Eastern Green Link 3 (EGL 3) and
Eastern Green Link 4 (EGL 4)

Document: Environmental Implications of Change (EIC) – Section 1
Anderby Creek Landfall to Candlesby

EGL-WSP-CONS-XX-RP-YC-207

April 2026

**Image 1: Proposed Changes to the Order Limits for Section 1 Anderby Creek
Landfall to Candlesby**

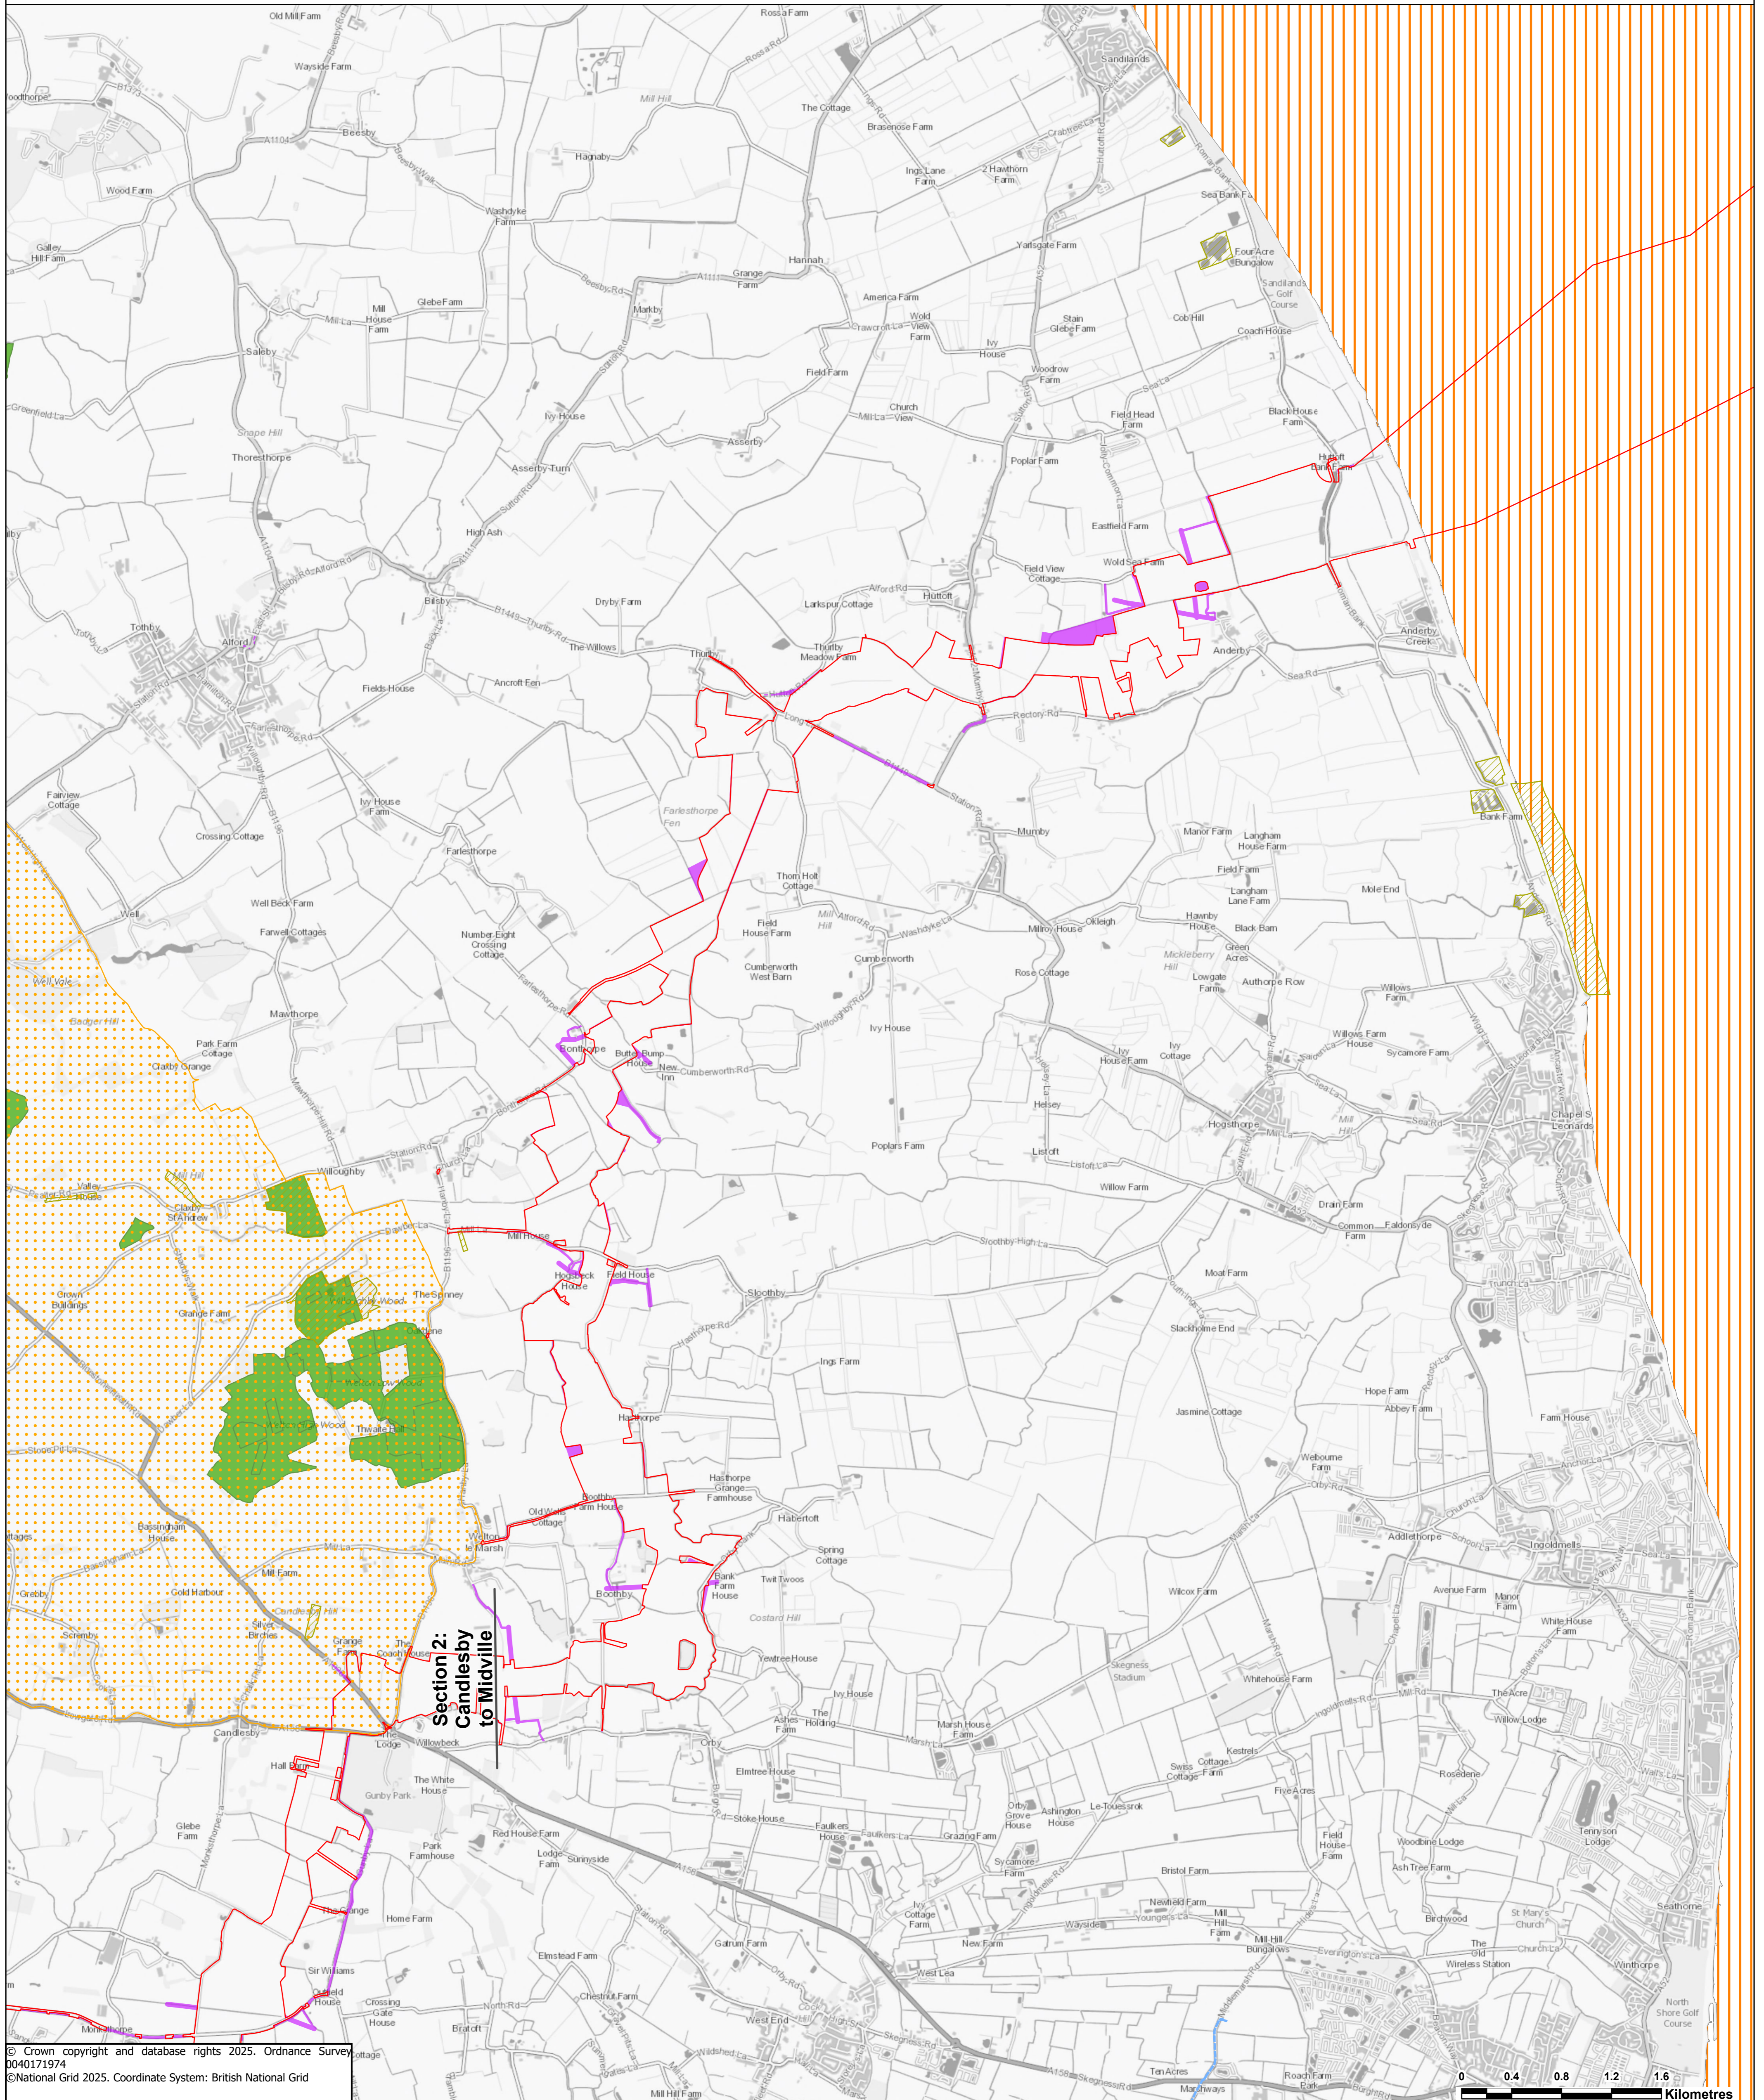
- 1.1.6 **Image 1** presents the Draft Order Limits from Stage 2 consultation 2025 and the proposed changes that have since been incorporated into the Order Limits (Additional Areas for Targeted Consultation 2026) for Section 1 Anderby Creek Landfall to Candlesby.

**EASTERN GREEN LINK (EGL) 3 & EGL 4
 Additional Areas for Targeted
 Consultation 2026 - Detailed Plans
 Section 1
 SHEET 5 of 6**

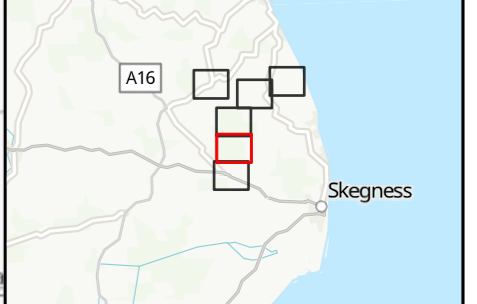
Changes 1-54 (1.4 ha) and 1-57 (1.3 ha) affect fields (1-54 and 1-57) and an area indicated by aerial imagery to be garden to Hogsbeck House or grassland (1-54), which did not fall within the draft Order Limits at Stage 2 consultation. The changes in this area relate to works to existing utilities and access for this and would not introduce any new significant effects.

- Change 1-64 – a utility diversion and land drainage would cross through an area of medieval earthwork ridge and furrow (MLI97834). The remains are considered to be of low heritage value for their archaeological interest to provide evidence on agricultural practices and land use in the medieval period. The utility diversion and drainage would impact the earthworks, resulting in a magnitude of impact of low. On an asset of low value, this results in a significance of effect of minor adverse
